# TOWN OF PLAINFIELD PLAN COMMISSION REPORT

**DATE:** 08-07-2023  
**CASE NO.:** [DP-23-037](#)  
**PETITIONER:** Evo Development  
**REQUESTED ACTIONS:** Architectural and Site Design Review for a proposed drive through restaurant  
**LOCATION:** 405 South Perry Road  
**PARCEL SIZE:** 1.3 acres+/-

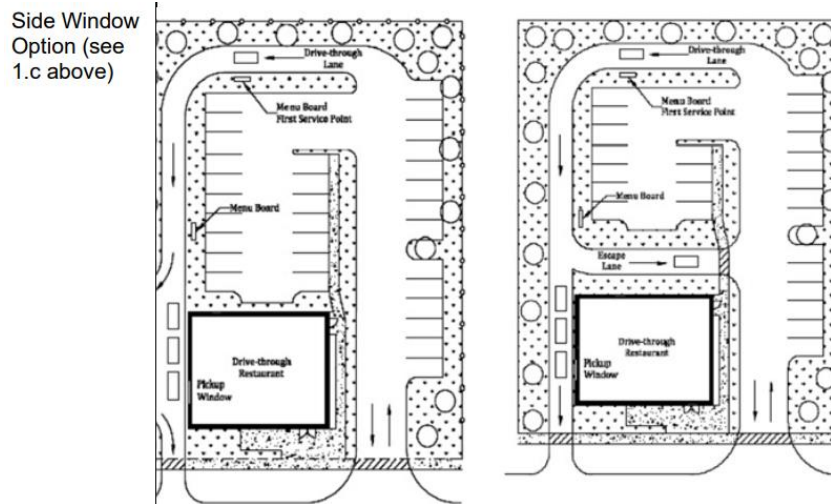
As noted above, the site is within an existing commercial subdivision which has a platted 30' Utility and Drainage Easement. The easement would prevent the building from being 20' from the west property line. The applicant's proposed layout shows the building being located approximately 100' from the Perry Rd. right-of-way. The excessive

distance appears to be necessitated by operational requirements of the drive-through which includes a waiting area located beyond the window.

The proposed drive through includes a pickup window on the side of the building and this design may be approved by the Plan Commission. Staff would note that the side window option was intended to offer flexibility in building design while still maintaining a building-forward site layout.

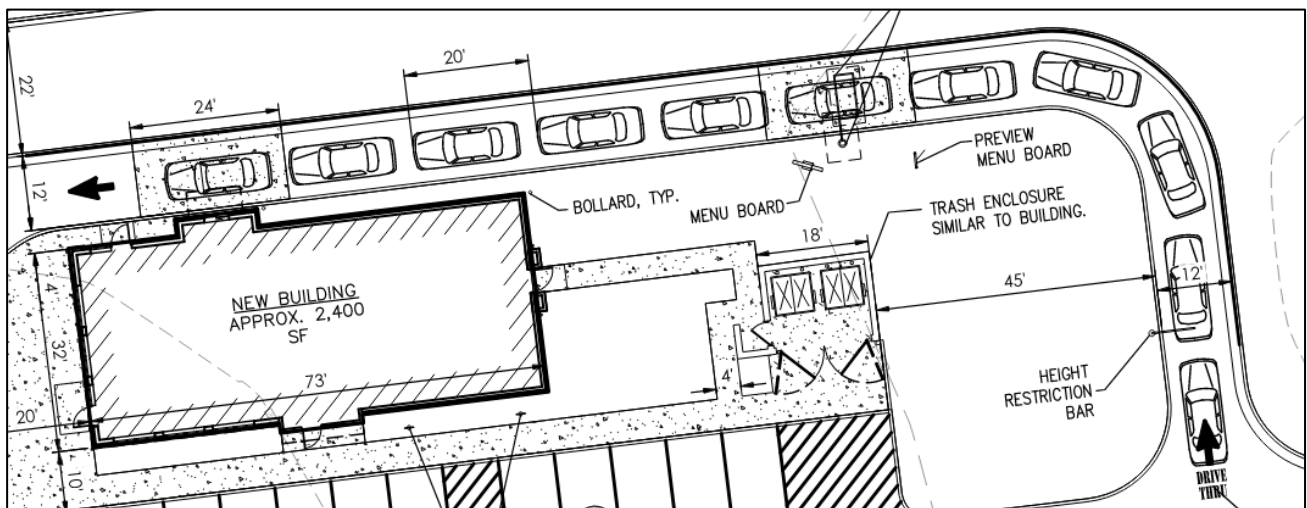
The drive-thru appears to meet Article 4.1D6 that requires 5 waiting spaces exist prior to the ordering location. Drive-thru traffic is designed to exit to a shared interior access drive between this parcel and the parcel to the north where a previous easement has been created.

Sidewalks are shown to connect through the site from Perry Road to Pine Crest Drive (note the above image for drive-thru count is a previous version). Existing sites along Pine Crest Drive have not been developed with sidewalks. In order to provide a connection of the walkway, Staff will recommend the inclusion of a Special Crosswalk Detail in accordance with Town Standards in order to connect to the 8' asphalt path that exists along the west side of the private street. Details for this connection can be coordinated through the Civil Review process.
